MEMORANDUM

From:	Tina Cuss Ecology Officer		
Service	WBC Ecology	App No:	252001
Address:	9 Hart Dyke Close, Wokingham, RG41 2HQ.		
Proposal:	Householder application for the proposed erection of single-storey rear extension with 2 no. roof lanterns following demolition of existing conservatory and pergola. Loft conversion creating additional accommodation with 1 no. dormers and 1 no. rear Juliet balcony. Single-storey extension to garage including loft conversion creating habitable accommodation with 1 no. dormer.		
Type of Development:	Other Householder		
Site Visit Made:	No

Figure 1. Preliminary Roost Assessment Survey Findings

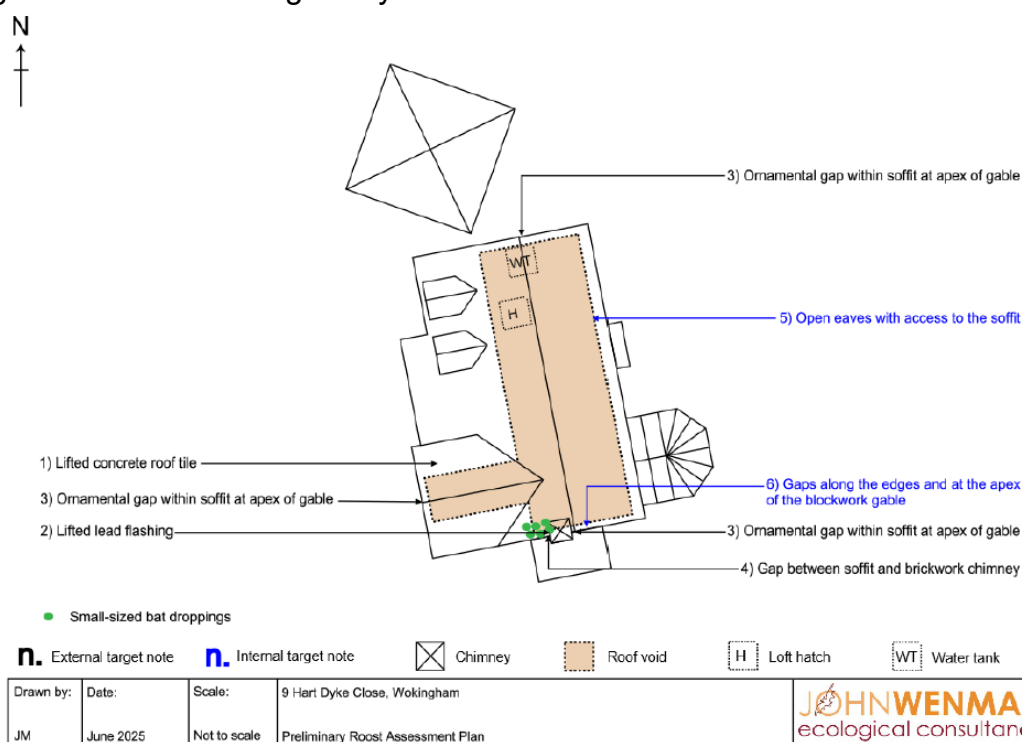
The PRA external inspection recorded slight lifting of the lead flashing and gap at the base of the southern chimney gap between the soffit and wall and against the southern brickwork chimney and ornamental gaps at the apex of each gable. In the internal inspection of southern blockwork gable with six small-sized droppings were observed at its base.

While the roof void is of a suitable size and condition for void dwelling bats and the lifted lead flashing and gap between soffit and chimney at the southern gable directly lead inside no evidence of bat species such as brown long eared bat were found. The lifted tile to the front gable and other potential roosting features are suitable for crevice-dwelling bats such as pipistrelle. Evidence of crevice-roosting species is regularly hidden from view in areas such as gaps between tiles and internal linings/insulation including cavity wall.

Ecologist concluded that the loft conversion and extension to the house will not impact the confirmed roost at the southern gable end or any of other the potential roosting features they identified. They state that the existing soffits and gap under lead flashing at the southern end will be retained unaffected and the loft conversion will not change the availability of the southern gable wall, which will remain separate and insulated away from the converted living space, for roosting bats. There is a residual risk of indirect impact, and of a change in the status of the roost before he work begins, therefore, a precautionary approach to specific aspects of the work under a non-licensed method statement should be adhered to in order to avoid indirect temporary disturbance of the low suitability features to be retained across the southern elevation of the building as detailed in the Non-Licensed Method Statement Section 6.4, and to confirm there has been no change in the roost status. Provided that the proposed void conversion does not impact bat or the roost in the gable end I support the conclusion therefore it is unlikely that there would be any direct loss or damage of a bat roost. If the precautionary mitigation measure proposed are secured by planning condition, there is no ecological objection to the development as proposed.

Condition: Unless otherwise agreed in writing by the council, all works are to be carried out in strict and accordance with the recommendations and proposed Non-Licensed Method Statement given in Section 6.3 and 6.4 of the submitted

Preliminary Roost Assessment (John Wenman Ecological Consultancy, Ref R2974_PRA_a, June 2005). A suitably experienced ecologist must undertake a site walkover/check not more than three months prior to commencement of development to confirm that conditions have not changed since the most recent survey.
